Access Compliance Report Public Rights-of-Way (Curb Ramps)

Main Street: PACIFIC_AVE		Cross Street: S_BROOKHURST_ST		Location:	SW
ADA ID: RPAT211122135325	Ramp Type:Type 1 - Perpendicular	Initial Pass/Fail: Pass	Overall Compliance: No	Severity Score:	5
Codes/Mitigation Info/Possible Solution			Field Measurements/Component Compliance

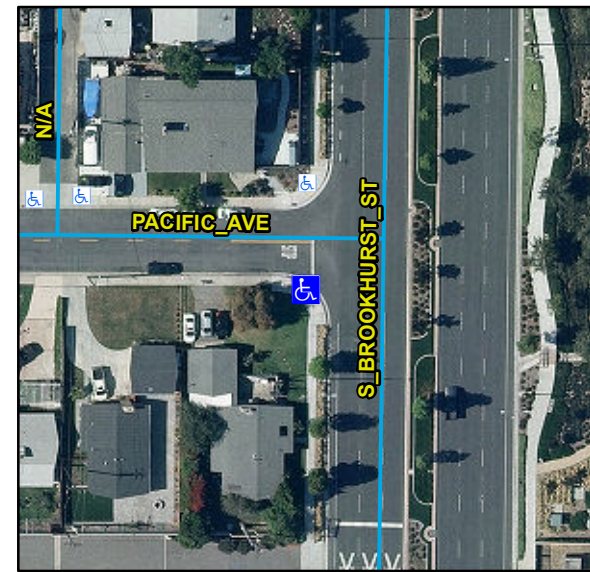
Remove & Replace Entire Ramp. Remove & Replace Gutter.

R304.2.2, R304.2.1, R304.5.4, STD 1115
